## **RESPONSE TO REQUEST FOR ADDITIONAL INFORMATION: ALEXANDRIA PARK COMMUNITY SCHOOL REDEVELOPMENT-MOD-2 (SSD-8373-MOD-1)**

This letter is prepared on behalf of School Infrastructure NSW (SINSW) to respond to NSW Department of Planning, Industry and Environment's (DPIE) request for additional information for SSD-8373-MOD 2 of 7 September 2020.

Figure 1 Proposed additional trees

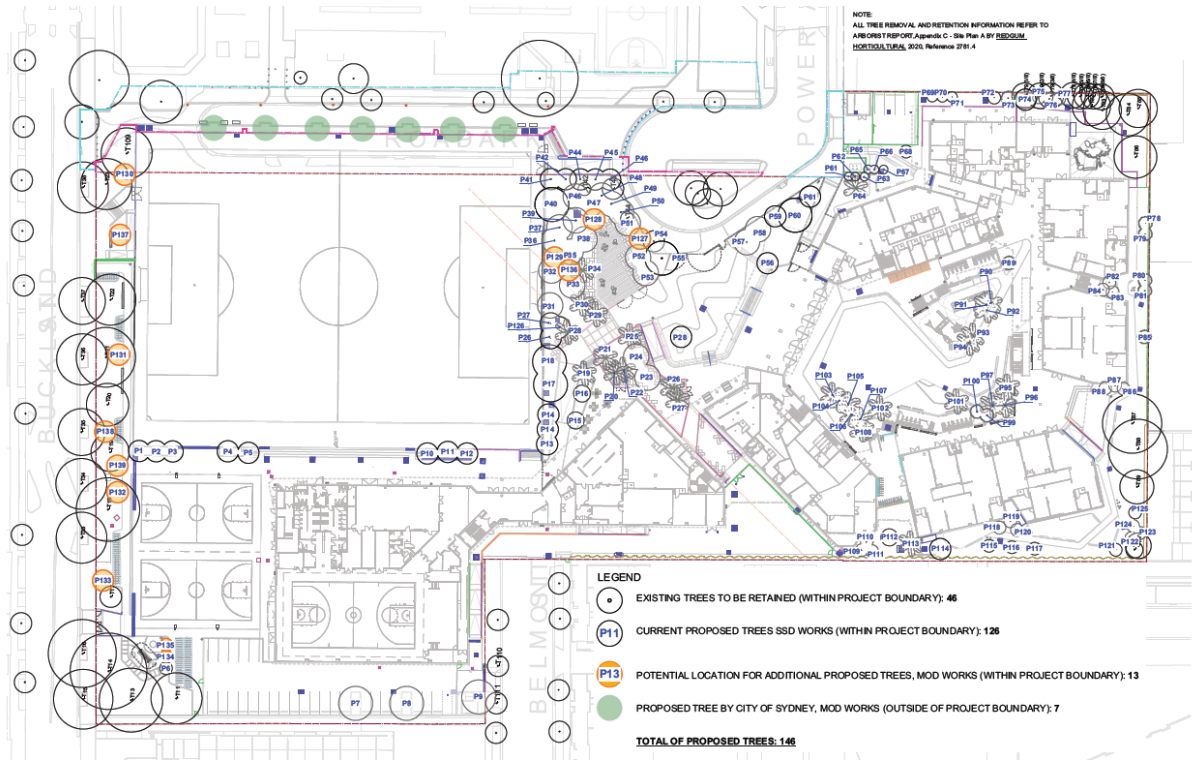
- Clarification on the proposed tree planting locations in the site.
- Clarification on the discrepancy between the tree loss assessed in the AIM and the EAR.
- Opportunities for increasing the tree canopy across the site and adjacent Alexandria Park to compensate for the loss of tree canopy at the site.
- Alignment of the project with key State and Local Government strategies to increase tree canopy coverage in Greater Sydney.
- Clarification that the increased biodiversity impact does not require a biodiversity development assessment report under section 7.17 of the *Biodiversity Conservation Act 2016* (BC Act).

The Proposed Tree Plan at Figure 1 and Appendix B shows the potential location for 13 proposed additional trees along the Buckland Street frontage and within the site, and 7 trees to be planted by Council along the now closed Park Road. These 20 trees are in addition to the 126 trees proposed under the original SSD.

The replacement trees along Buckland Street will provide a secondary canopy layer by using smaller tree species. This will reinforce the screening provided by the existing canopy by creating a secondary layer of screening. The intention is that the replacement trees will be provide mid canopy cover, as per the information provided in Table 1 below and the species schedule in Appendix F.

There are no further opportunities for tree planting within the remainder of the site is needed for learning and play spaces. The total proposed trees are 146, this is 1.6 for every tree that is being removed for the whole project.

Figure 2 – Alexandria Park tree canopy

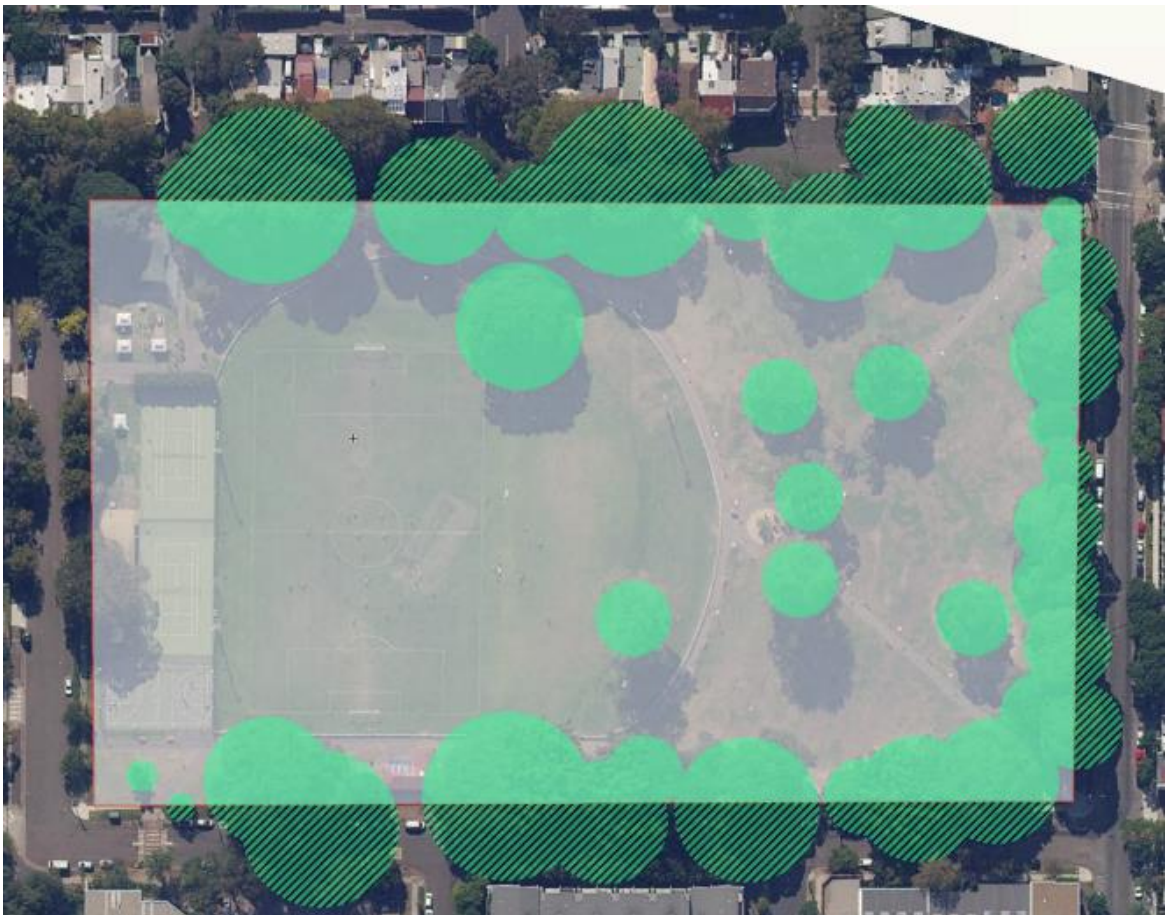
The percentage of canopy cover for Alexandria Park Community School is 13%. This is below the 40% canopy target outlined in the NSW Government’s Premier’s Priority: Greening Our City and the *Draft Greener Places Design Guide, 2020* prepared by GANSW.

- The new high-quality sports field addresses community need and provides the school with a facility that will enhance the educational outcomes for its students.
- Re-planting is 1.6 trees for every tree being removed, more than a typical 1:1 replacement.
- The landscaping intent of the replacement trees along Buckland Street is to provide a secondary canopy layer by using smaller tree species. This will reinforce the screening provided by the existing canopy by creating a secondary layer of screening.
- The canopy cover can be offset in Council’s parks and reserves, including Alexandria Park. Alexandria Park and bordering streets have a canopy coverage of 48%, which exceeds the 40% target.
